Technical Note

Document Ref 2772 TN 002

Project Title Albert's Norden – Front Extension / Canopy and Balcony

1.1 This technical note has been prepared to address Pre-Application comments Rachel Carney the Principle Planning Officer at Rochdale Borough Council in her email dated 9th July 2024, extract below: -

Image 1 Ground Floor Plan showing indicative structure over

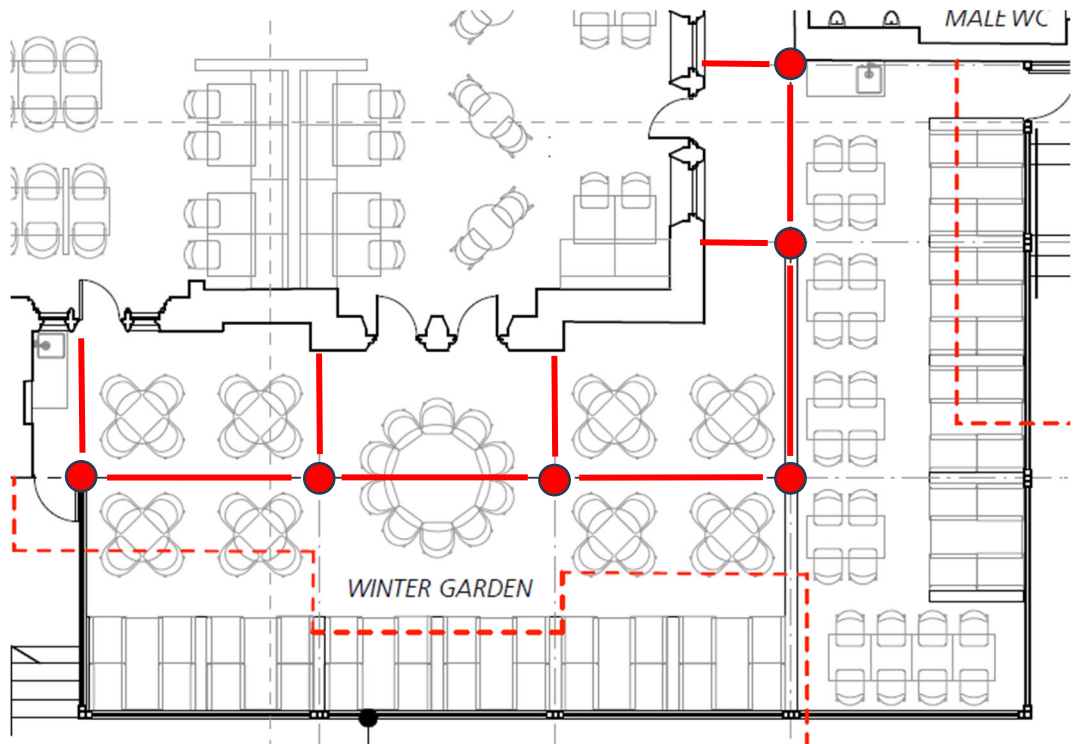
- *Front extension / canopy – This looks relatively lightweight and is more sympathetic to the building than the existing structure. It would however still be preferable if this could be located to the side elevation. In the meeting we requested that additional information structural information be submitted. It is recommended that this be provided at planning application stage.*
- *Front extension balcony – There are still concerns over the balcony as this would appear as a more substantial structure and would sit awkwardly with the canopy. It is recommended that this element be omitted from any future application. If you wish to proceed with the balcony, it is recommended that large scale details are submitted as part of the application so that we can ensure that this element is as lightweight as possible.*

3.2 The balcony structure will consist of a series of steel beams supported on steel columns at regular centres, as indicated below. The columns indicated by red circles are will 114mm circular steel columns, and the beams which span between will be 250mm deep RHS beams which will be concealed with the balcony floor build up. These beams will preform the triple function of supporting the balcony structure, the balustrade and the proprietary canopy structure.
